TEMPORARY DRAINAGE PROPOSAL

APPLICATION SITE OF PROPOSED TEMPORARY PUBLIC VEHICLE PARK FOR MEDIUM GOODS VEHICLES FOR A PERIOD OF 3 YEARS AT LOTS 1621, 1623 (PART), 2700, 2703, 2704 (PART), 2705 (PART), 2706, 2707, 2708 (PART), 2709 (PART), 2710 (PART), 2711 (PART) AND 2713 (PART) IN D.D. 129, LAU FAU SHAN, YUEN LONG, NEW TERRITORIES.

PREPARED FOR A_YL-LFS_512

Response to Comments on Temporary Drainage Proposal (Issue 1)

APPENDIX D
DESIGN CALCULATION OF THE PROPOSED DRAINAGE

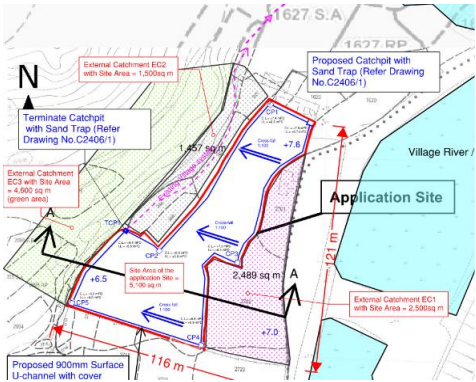
4.	The up-hill ground to the west of the application site is generally higher. Since the overland flow from the adjacent lands shall be properly intercepted, external catchment to the west of the site (other than EC1 and EC2) shall be considered in the calculation	Noted. The up-hill ground to the west of the application site was included as external catchment EC3 in the calculation. Please refer to the revised Appendix D - Drainage Calculation.
